Comment on the Revised Operating Conditions of
New Zealand Windfarm Limited's
Te Rere Hau Windfarm,
355-573 North Range Road, Palmerston North,
Under Section 128 of the Resource Management Act

Submission from
R. C. Wallace & N. J. Banks-Wallace
48 Ridgeview Rd.,
RD 1,
Palmerston North.

Figure 1 : Plot of the Wallace complaints according to days of the week and time of day.

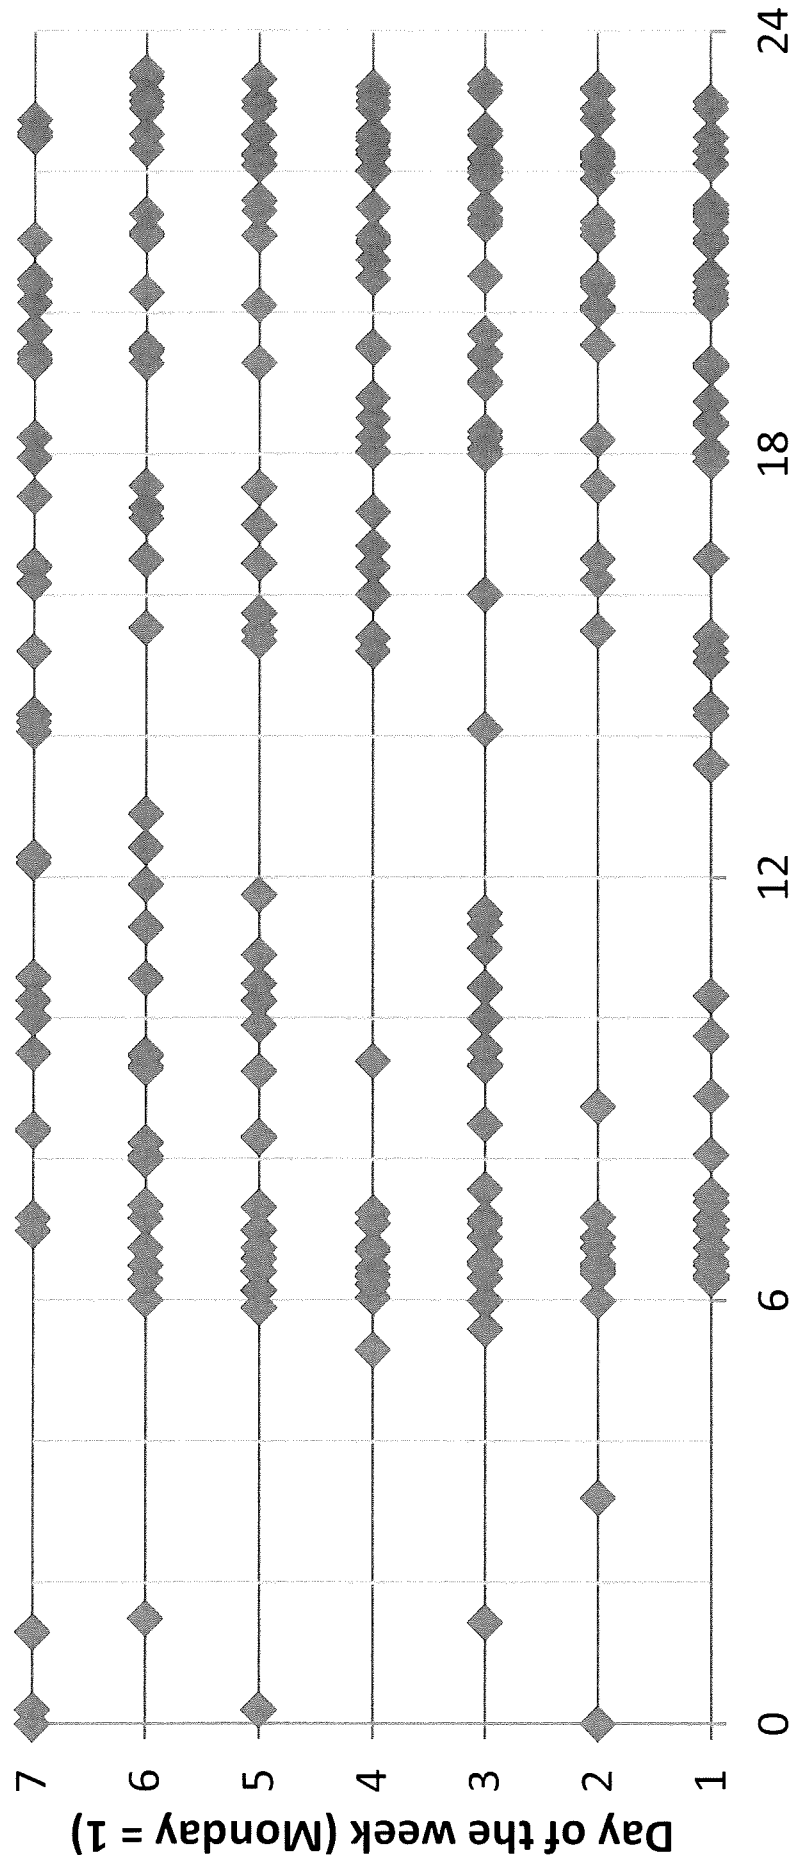
7pm – 7am obviously accommodates the "night-time" aspect but when does the "evening" begin? Wikipedia suggests that "evening" starts at 5 pm. However if the conditions of the new consent order are to mitigate some of the complaints of the community then it is appropriate to accommodate the timeframes of those complaints. This would suggest that for us (see figure 1) this period of special conditions should extend from about 4pm to 7.30am.

..... from 7pm to 7am Should be modified to

..... From 4pm to 7.30 am
